BUILD CONTEST

Technical and Preliminary Design
Review Q&A Responses

Ocean Observing Prize Administration
Team

March 14, 2022

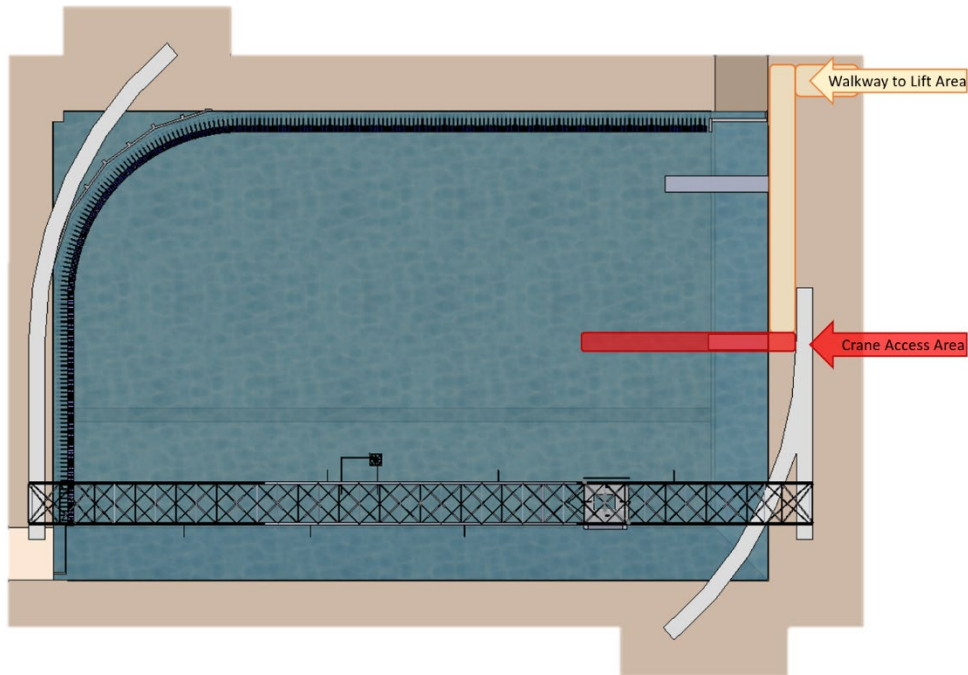
- Can you describe the crane that will be used to hoist vehicles into the test tank?
 - The MASK Basin has a center-line overhead crane with a single hook that can only reach ~1/5 of the length of the basin (highlighted in red in the image below). Your vehicle will be launched in this small area and moved either under its own power or towed by a small boat to the starting location. During recovery, your vehicle will again move either under its own power or be towed by a small boat to the crane recovery area, where the Carderock team will attach hoisting gear prior to lifting.
